2 SHEETS  
21B-991726

25 & 35(C)
TYPE DIAL
R.F. Mod-
ification

25 & 35(LC) TYPE DIAL RFI MODIFICATION
KTC
B-891726 SHEET 2

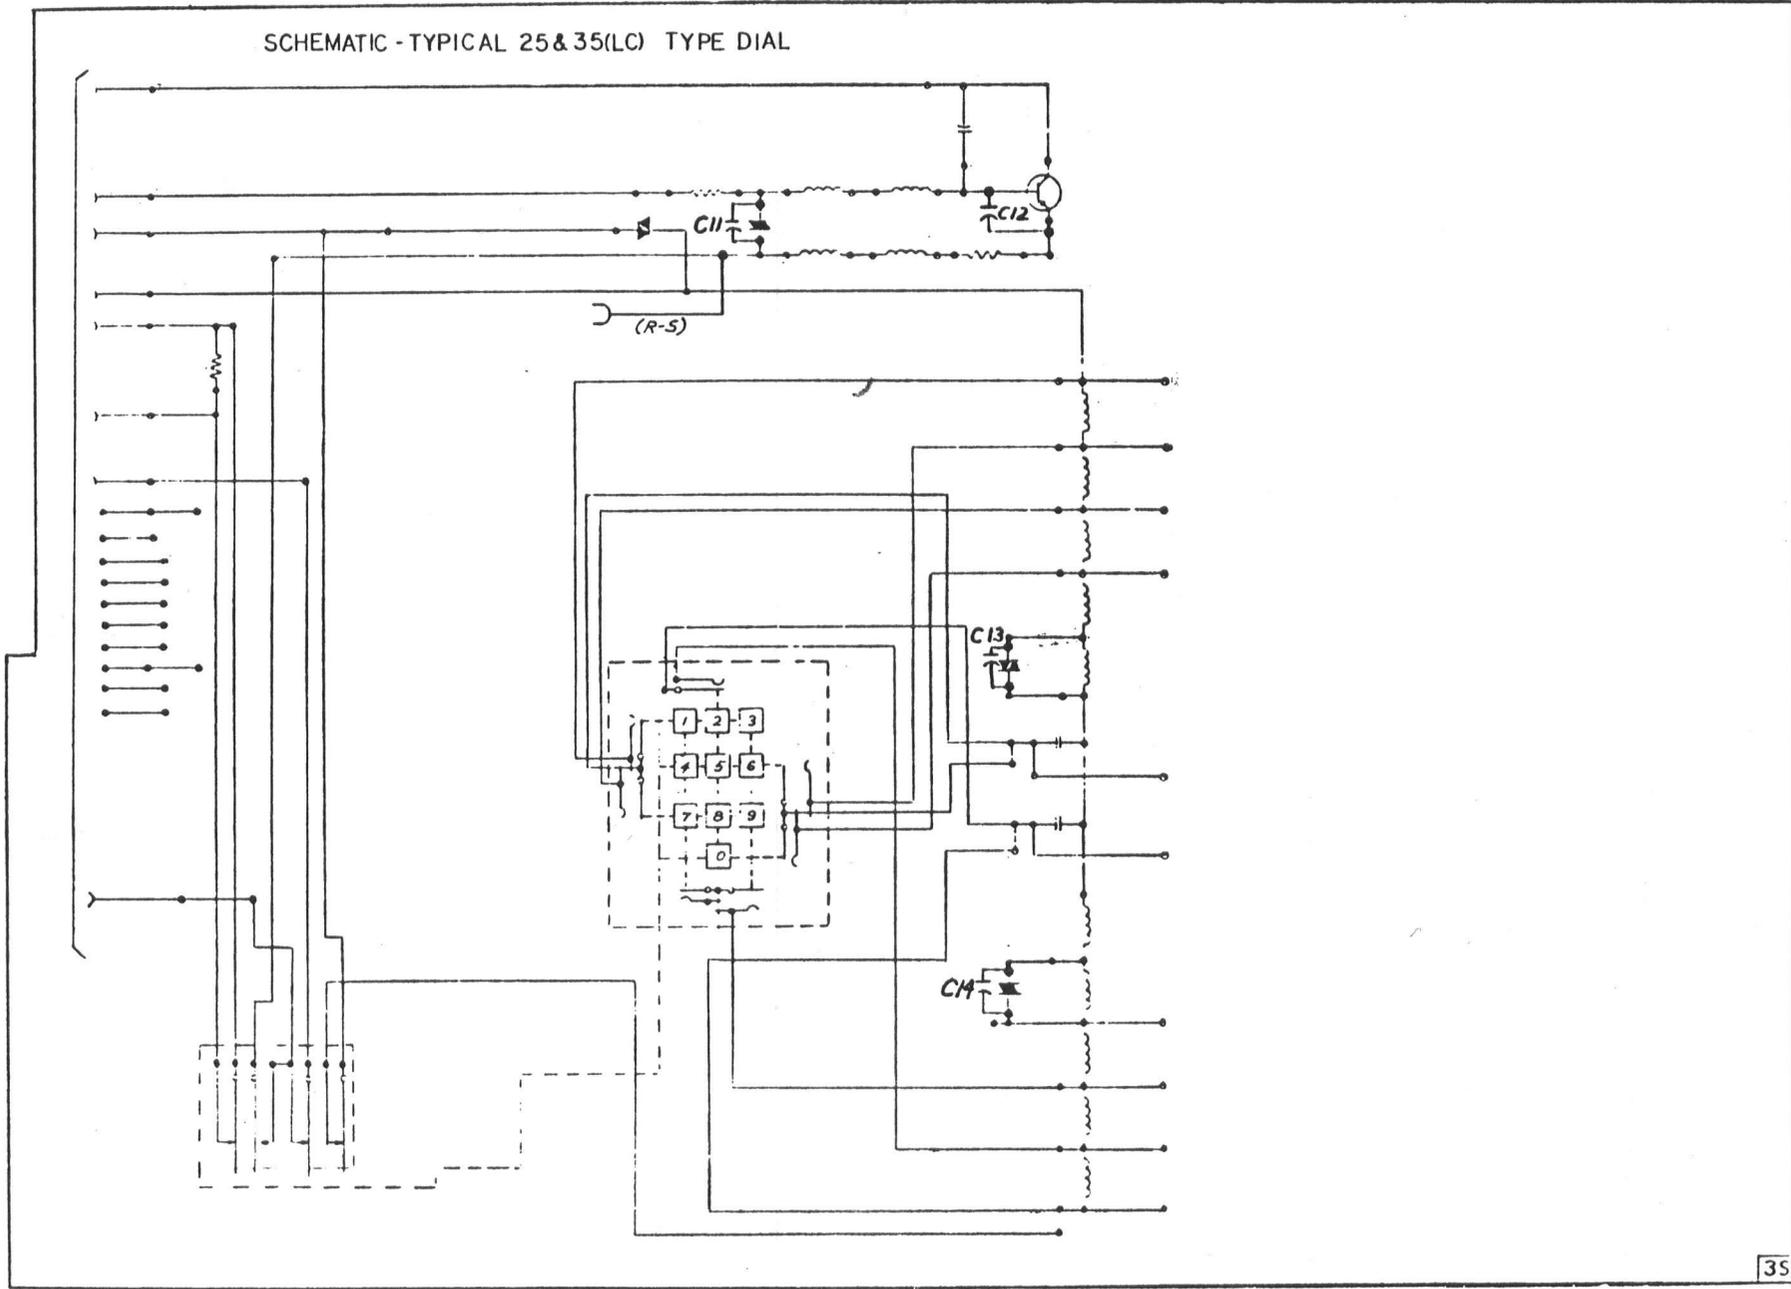
1. LOCATE (1) 0.01 uf (KS 19708-L4) CAPACITORS, ITEM 50, APPROXIMATELY AS SHOWN. (C12)
2. REPLACE VARIATORS RV1, RV2, AND RV3 WITH PREASSEMBLED VARIATOR AND CAPACITOR UNITS (B-991730) AND MOUNT AS SHOWN.
3. USE TAPE WHERE NECESSARY TO PROVIDE MECHANICAL ISOLATION.
4. RETUNE DIAL AFTER MODIFICATION.
5. PLACE A, "MODIFIED FOR R.F. SUPPRESSION," LABEL NEAR THE CODE STAMP ON THE FACE OF THE DIAL.
6. CAPACITOR C12 CONNECTS TO R2 AND GOES THROUGH HOLE 40b TO BE SOLDERED TO PATH BETWEEN HOLES 27a AND 27b.
7. DRILL 0.043 HOLE APPROXIMATELY AS SHOWN AND SOLDER AN 8 INCH (R-S) SPADE-TIPPED LEAD TO THE X CONTACT SIDE OF RV3.
8. PRINTED WIRING BOARD SHOWN FOR 25W3, 35A3A DIAL, AS TYPICAL. FOR OTHER DIAL CODES, ELECTRICALLY LOCATE COMPONENT ON PRINTED WIRING BOARD AS SHOWN ON SHEET 2, DIAL SCHEMATIC, TYPICAL.
